## Planning Commission Staff Report

**Project Type:** Site Development Section Plan

**Meeting Date:** July 9, 2018

**Description:** **18385 Chesterfield Airport Road, Lot A (Chesterfield Hockey Association):** A Site Development Section Plan, Landscape Plan, Lighting Plan, Architectural Elevations and Architect's Statement of Design for a 10.12 acre tract of land zoned "PC" Planned Commercial District located north of Chesterfield Airport Road and northeast of its intersection with Olive Street Road and northwest of its intersection with Wings of Hope Boulevard.

A020

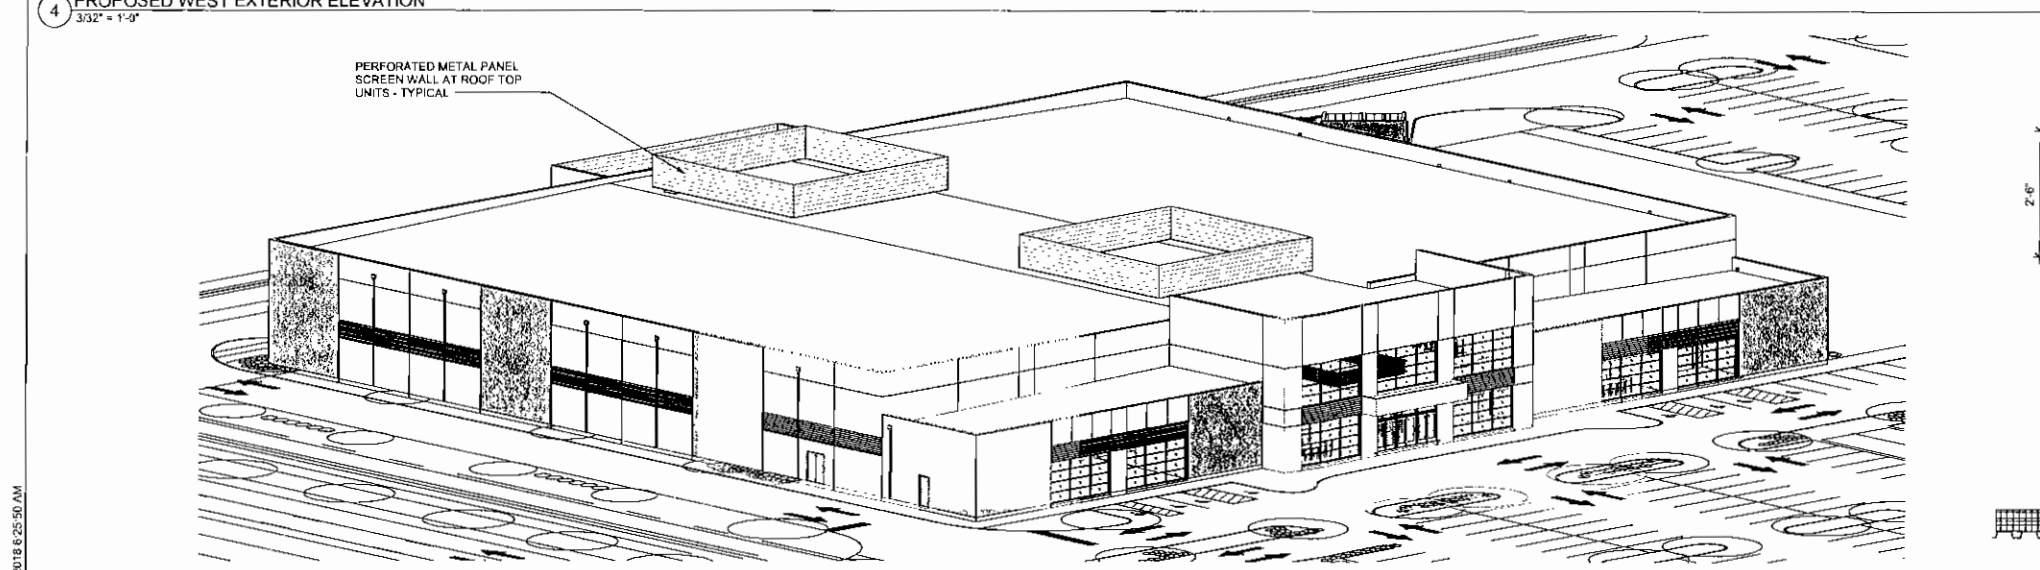
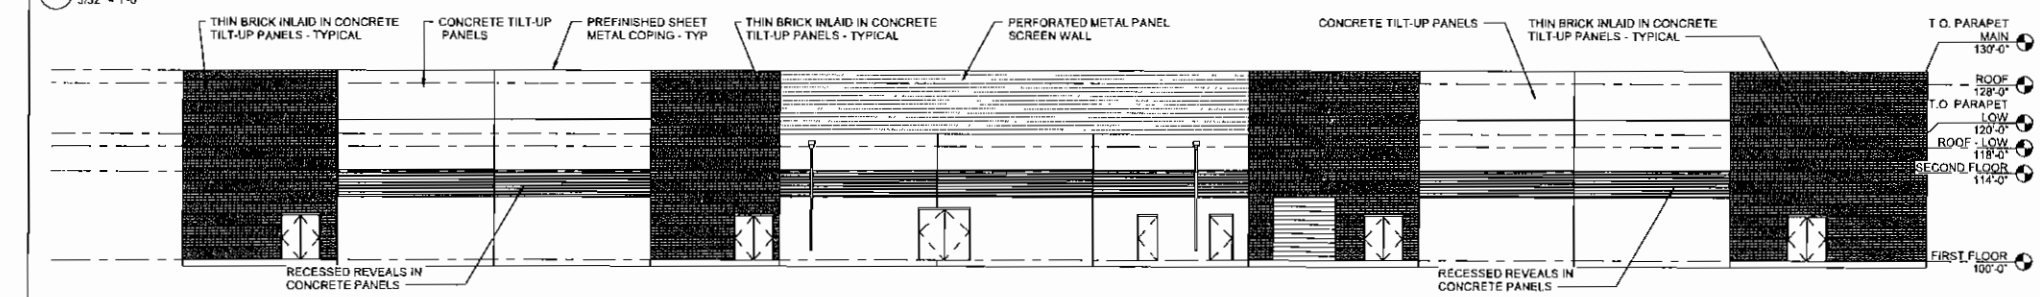
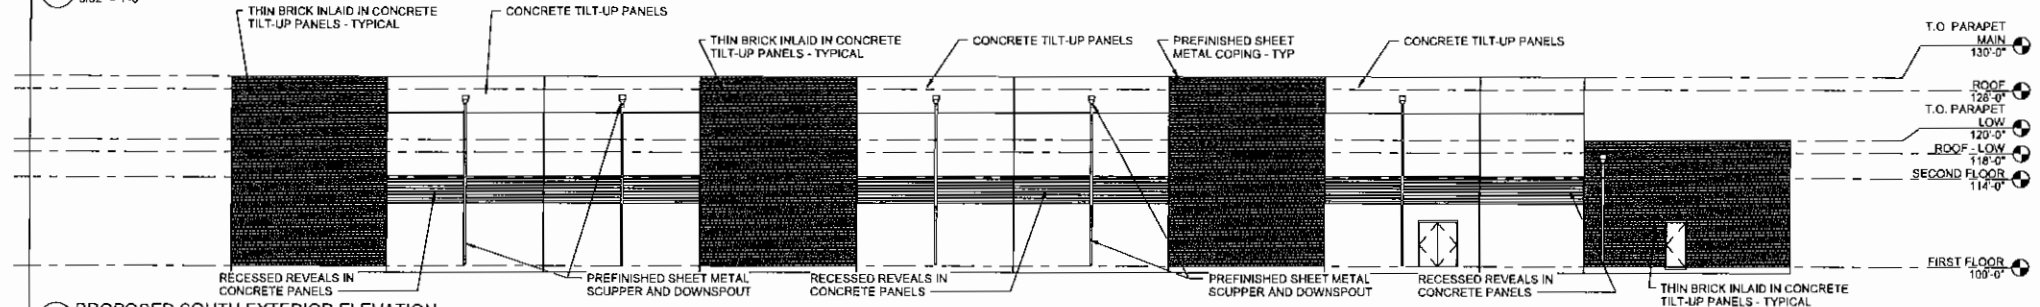
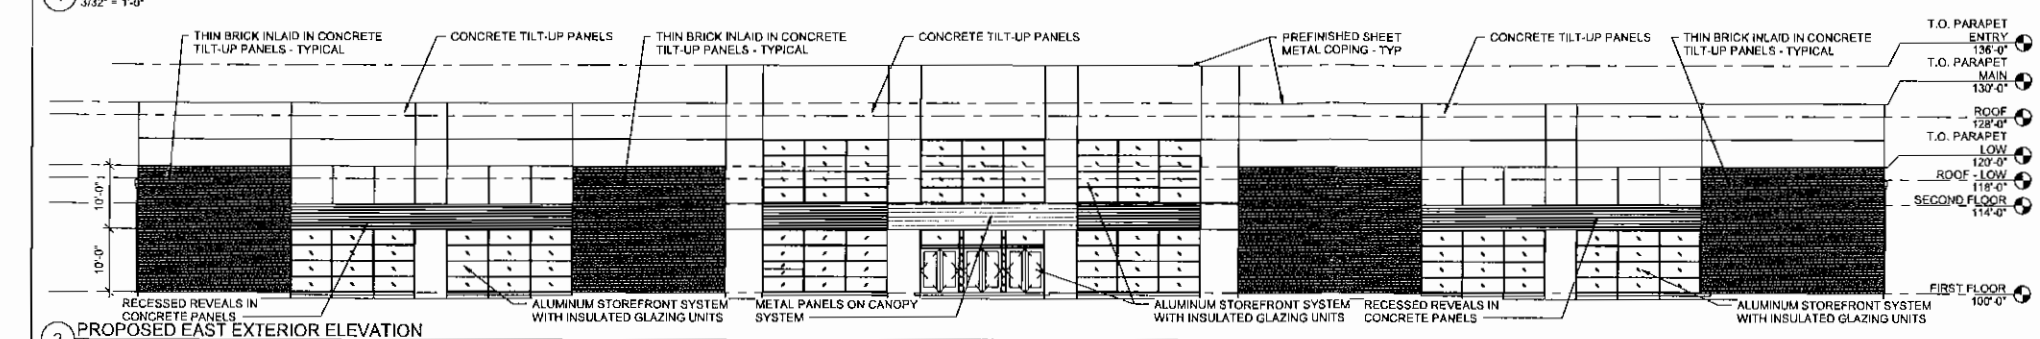
- **Façades of Buildings Along I-64/US 40**—Care should be taken to make sure that any portion of a building that can be viewed from I-64/US 40 or any arterial and collector roadways should convey the image of a high-quality office or commercial development and should be equally uniform in materials and attractiveness as the primary façade of the building if it does not face I-64/US 40 or the roadways. The intent is to avoid projects having their view from I-64/US 40 or the roadways appear to be the rear or side of a development.

*As shown on the Architectural Elevations, the proposed building features a four-sided design.*

Facing north and south, the side façades will also consist of the tilt up concrete panels with thin brick and painted tilt up panels with horizontal decorative recessed reveals to split up the panel. The rear façade facing west consists of the same material as the other three sides and contains the step-down portion of the building, where the ammonia equipment room will be located. The condenser for the ammonia system will be located on top of the ammonia equipment room. The condenser will be screened by a perforated architectural metal panel, similar to the architectural metal panel that will screen the HVAC units on the roof of the facility.

# SITE DEVELOPMENT SECTION PLAN

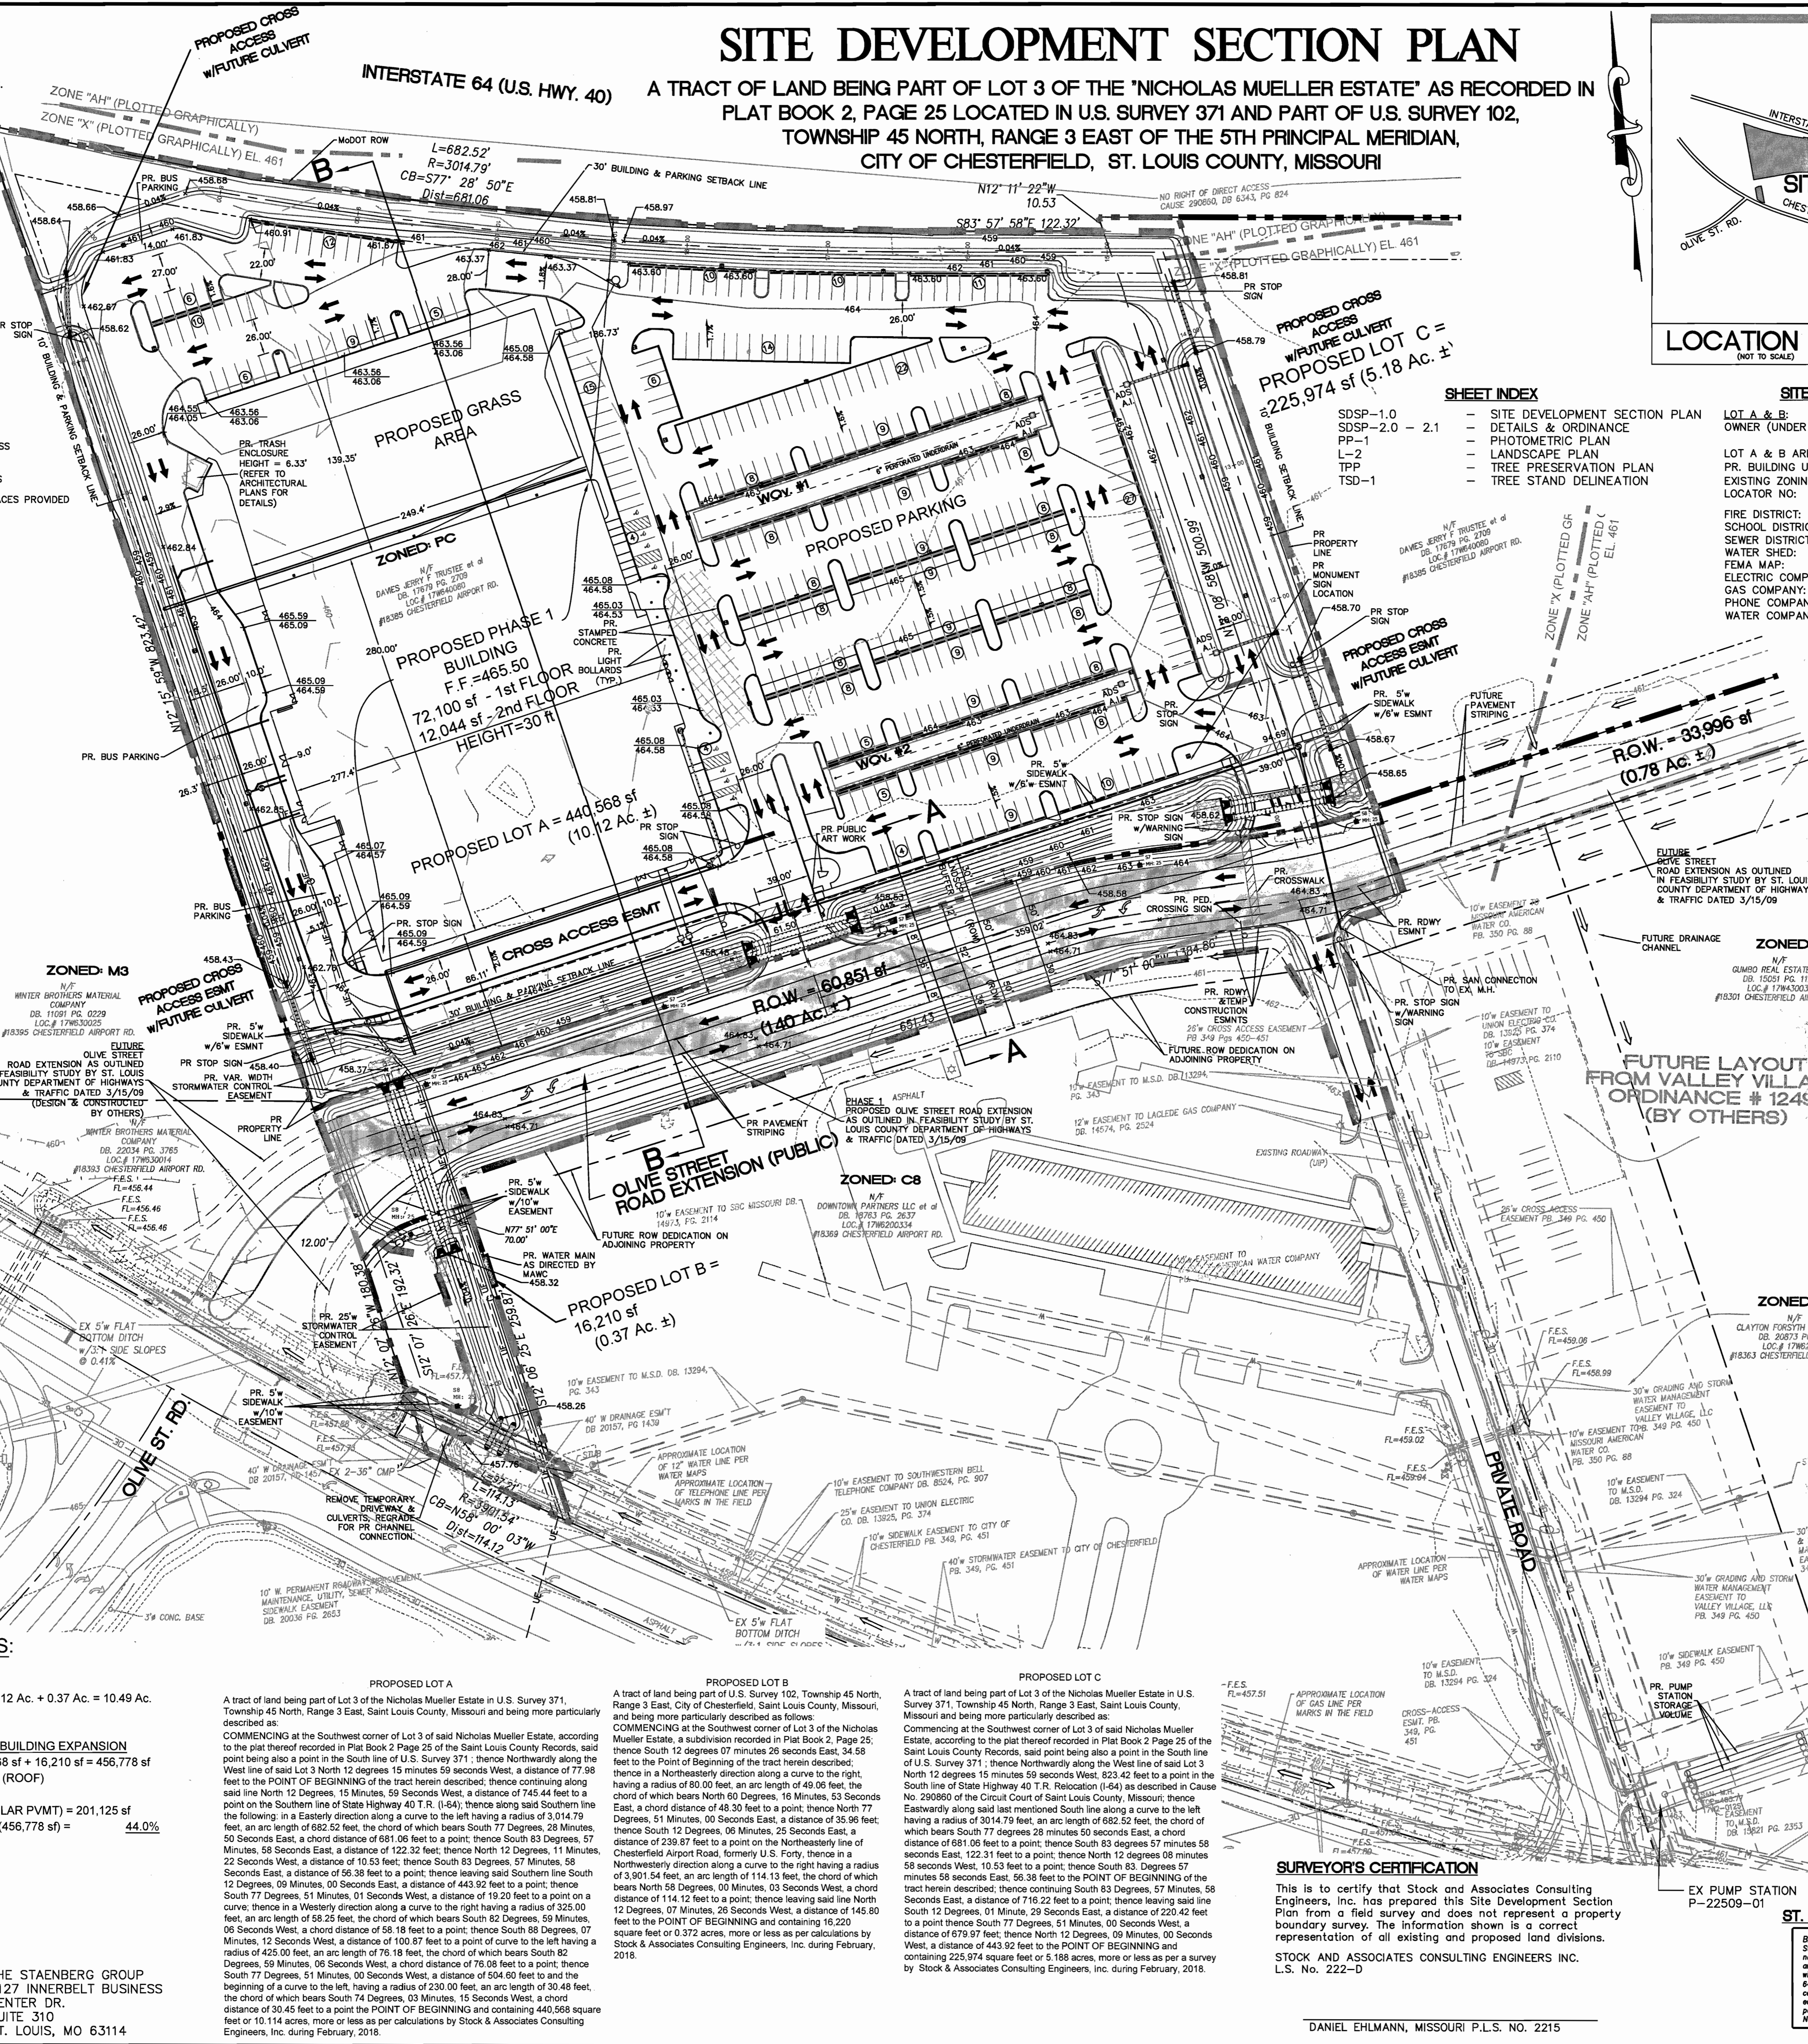
2. Provide traffic calming measures near the front drop off area.

*The applicant has revised the Site Development Section Plan to provide stamped concrete in the portion of the drive lane that is located in front of the main entrance.*
